## Restriction nr2

About replacing the SP100F, SP130F, SP140F and MIS10006, MIS10007, MIS10008, MIS130

Picture below shows placement for R19 on SP100F, SP130F and SP140F.

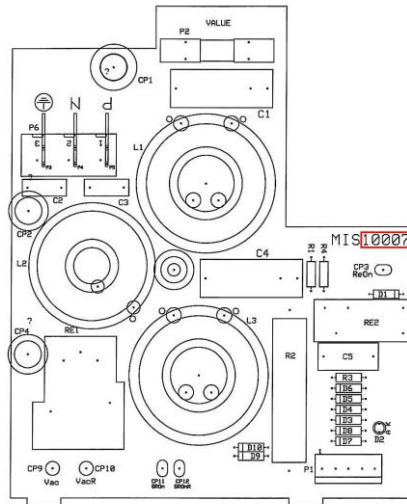
When replacing SP100F, SP130F or SP140F or MIS10006, MIS10007, MIS10008, MIS130 in an amplifier you need to make sure that the 33Ω resistor is NOT active at both R19 on SP100F/SP130F/SP140F and R5 on MIS100/MIS130.
